**Subject** ▶ Change of the washer which protects housing from anvil.

**For Models** ▶ 6903VD,6901D,6901VD(Cordless Impact Drivers) and 6907D(Cordless Impact Wrench)

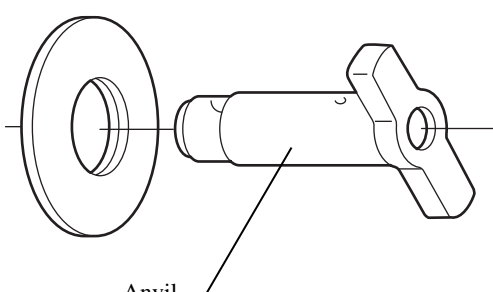
▶ Current	▶ New
Flat Washer 14(metal) Outer Diameter : $\phi$ 38	Nylon Washer 14 Outer Diameter : $\phi$ 34 (This washer has already been available for Model 6913D)

Item No.	Current part	Q'ty	I/C	New part	Q'ty	Note
	Flat Washer 14 267062-3	1	Yes	Nylon Washer 14 261099-2	1

6903VD : From serial No.514290E  
6903VDW : From serial No.33058E  
6907D : From serial No.5017E  
6901D : Discontinued since Apr.,1993  
6901VD : Discontinued since Apr.,1993
